**TOWN OF BROOKLYN
PLANNING AND ZONING COMMISSION
Regular Meeting Agenda
Tuesday, October 19, 2021 6:30 p.m.**

- a. Reading of Legal Notice: None.
 - b. New Public Hearings:
 - c. Continued Public Hearings:
 1. **SP 21-002:** Special Permit Application for Multi-Family Development (51 Condominium units) on south side of Louise Berry Drive (Assessor's Map 33, Lot 19), 13.5 acres, R-30 Zone, Applicant: Shane Pollack.

DATE: 4/23/2020	DRAWN: DNE
SCALE: 1" = 40'	DESIGN: NET
SHEET: 6 OF 11	CHK BY: ---
DWG. No: CLIENT FILE	JOB No: 20014

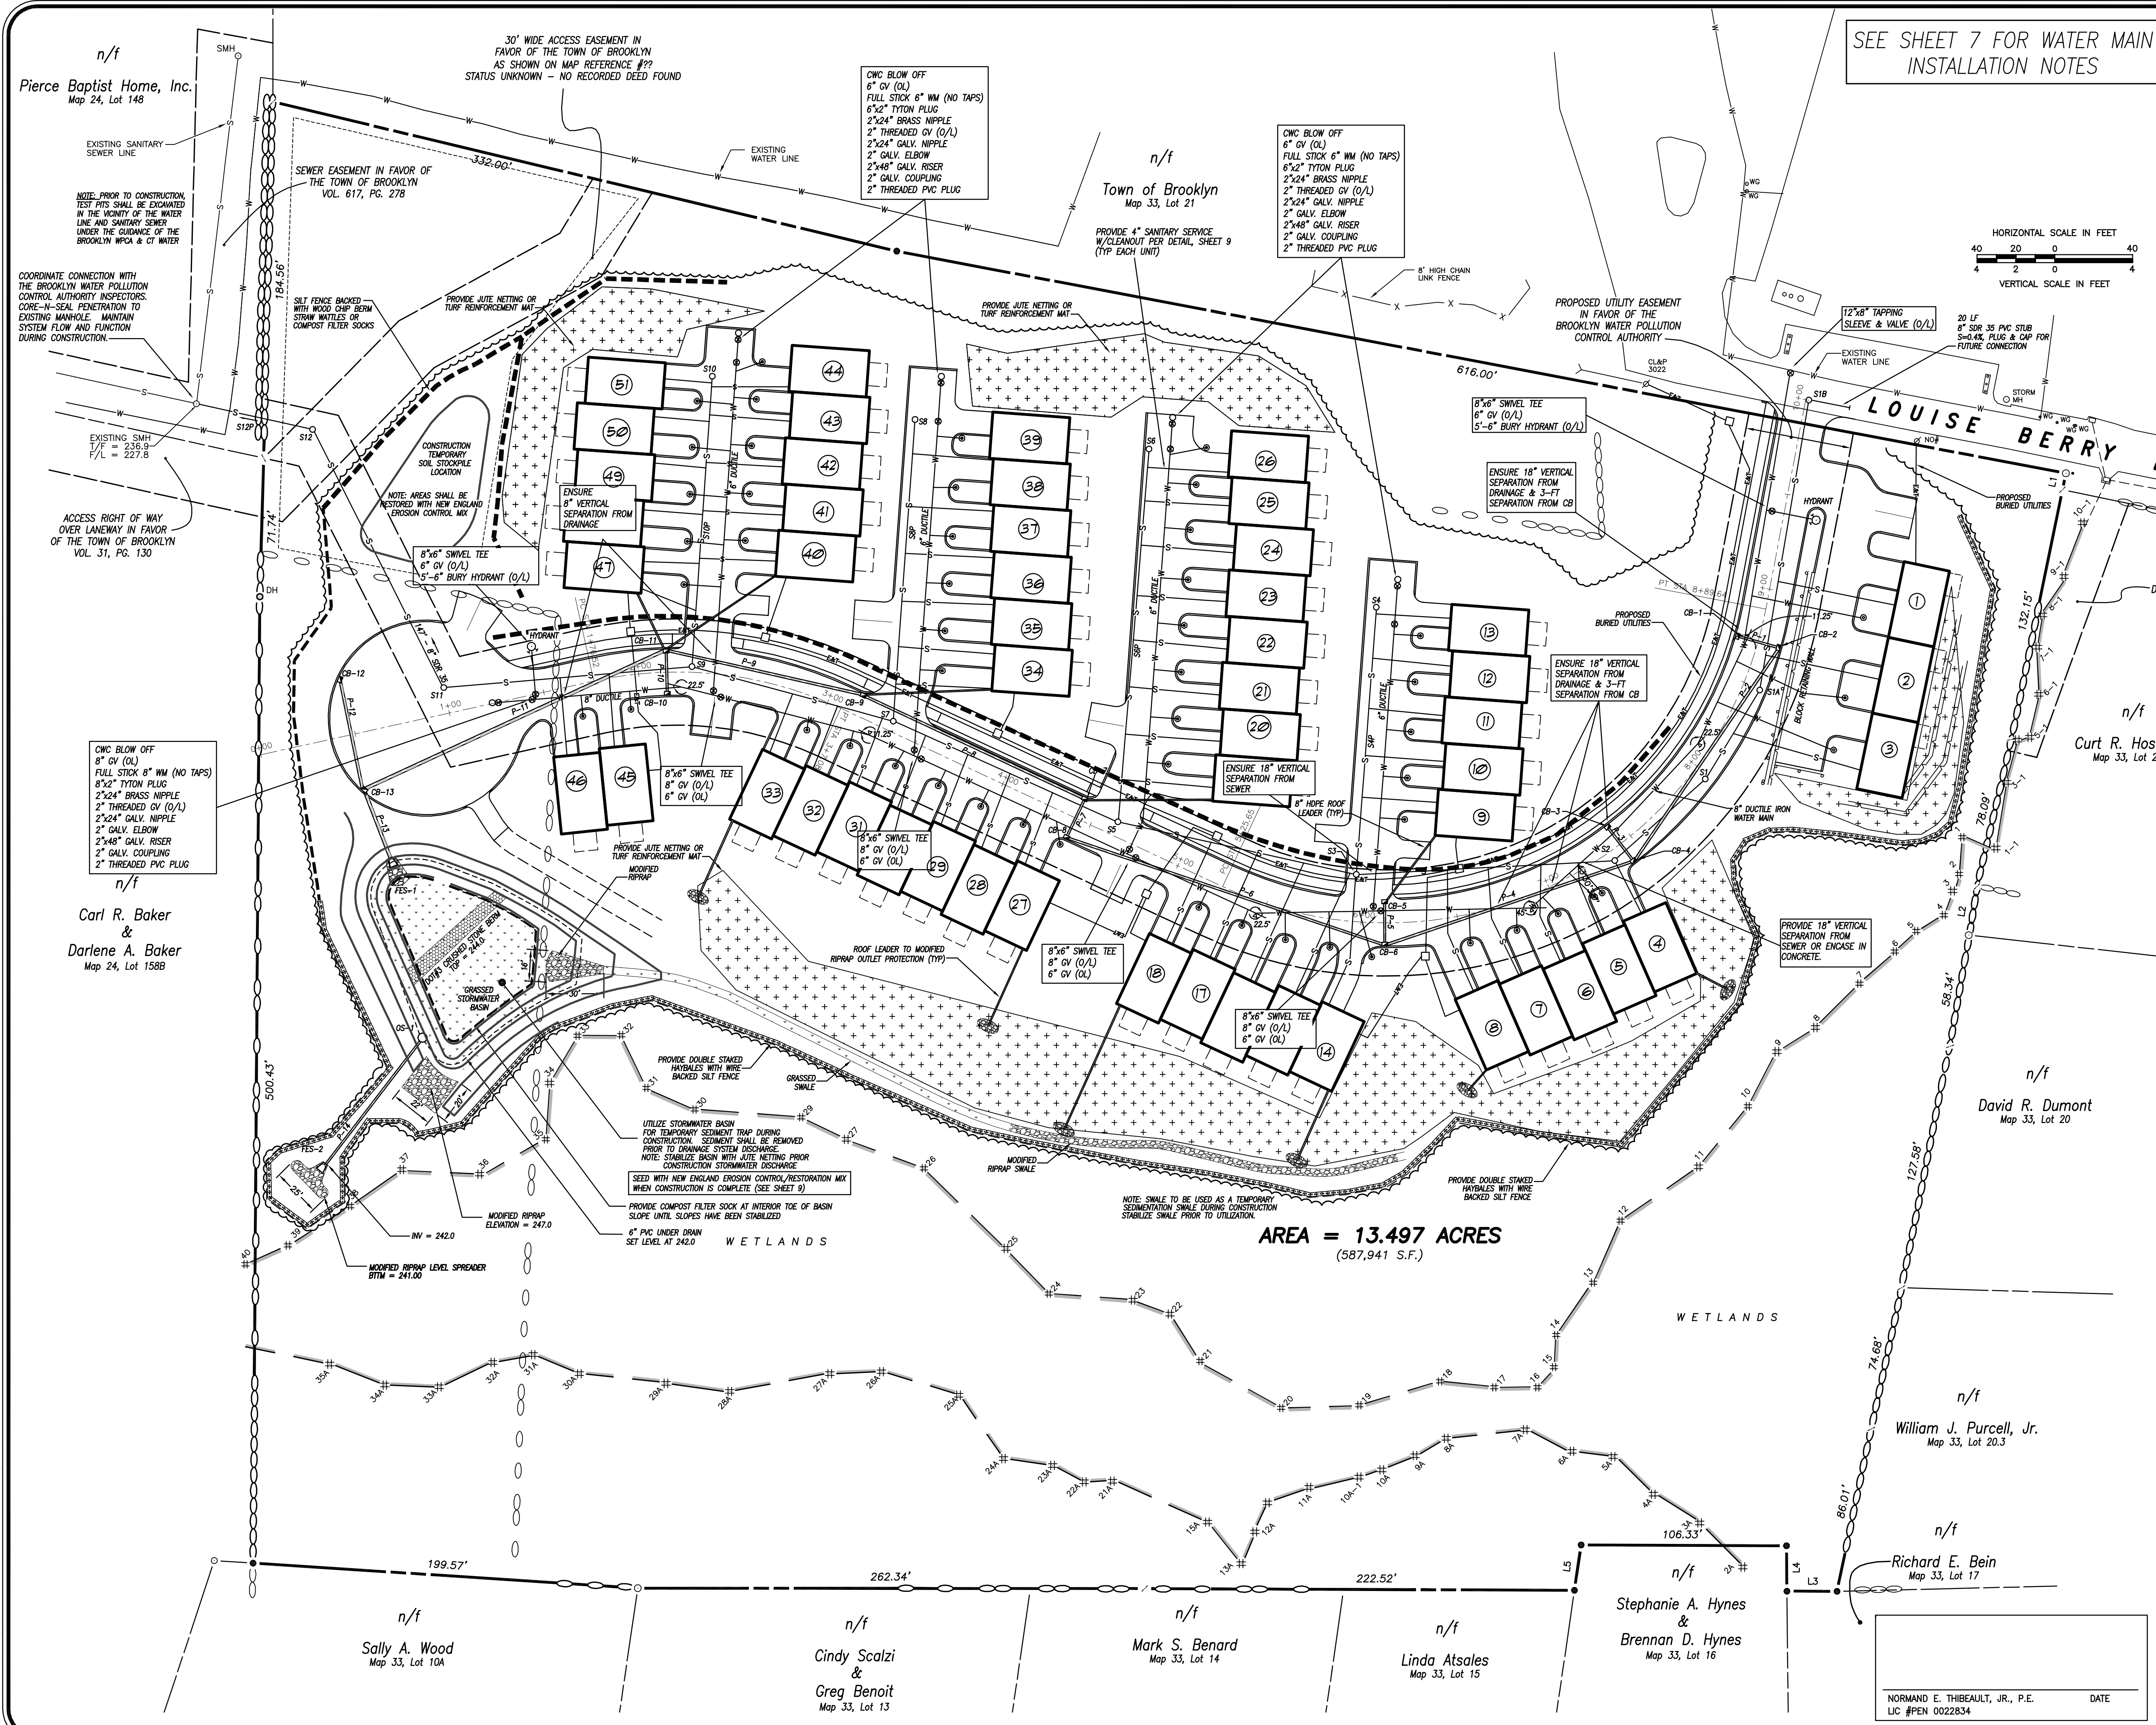
KEA states that building sewer cleanouts will be provided, however, they are not shown on any plan exterior of the building units. Furthermore, the way building sewer connections (individual units) are to be connected to a sewer line manifold or trunk line need to be shown on plan Sheet 5 of 9.

On plan Sheet 5 of 9, KEA has added an additional sanitary sewer manhole (S1) at STA 8+22.87 (8.12’ LT). However, if the connection of each housing unit (Nos. 1 – 3) to the sewer main is to be as depicted in the “Sewer Connection Detail” shown on Detail Sheet 3 (Sheet 9 of 9), then the sewer main needs to be extended further up the road and an additional sewer manhole constructed at STA 9+35, more or less.

Additional erosion and sediment control (E&S) has been added to the plan. However, the E&S to the west of the stockpile shown on Sheet 5 of 9 should be moved to a line that is 20' from the west boundary of the stockpile to allow for movement of heavy equipment. As shown, the E&S line is too restrictive for that kind of maneuvering.

23. As shown on the plan, the temporary sedimentation basin will be constructed in an area where there is a six (6) foot difference in elevation across its width (west to east). According to the “Temporary Sediment Trap Embankment Cross Section” located on Sheet 7 of 8, a 3’ (max.) deep level bottom excavation, starting on the west side of the basin will require about an 8’ deep excavation on the east side of the basin. If this is not the way the basin is to be constructed and instead will be a combination of berm construction on the low (west side) and 3’ deep excavation on the east side, that should be shown in the detail on Sheet 7 of 8. In any case, no deep test holes have been dug here to show where groundwater may lie or where an average seasonal high water table may exist, which would be evidenced by soil mottles, to see if there would be an impact on the basin. Constructing the basin with a earthen berm should be shown on the plans because of the large area of tree removal that will occur. How would accumulated water be managed for this basin? What would be the likelihood of an embankment failure if not built with an emergency spillway protected with at least riprap armoring? Furthermore, there is no sediment control system (silt fence or hay bales) surrounding the proposed temporary sedimentation basin, because any sediment laden water that rises to the point where it would flow through the stone dike, the dike will not necessarily trap fine particles of sediment with much efficiency. Also, the aforementioned sediment trap detail incorporates a weir of unknown length at the crest of the stone dike. An explanation of how the weir will function, knowing the pervious stone dike will allow the passage of water, is needed. Drainage calculations are also needed.
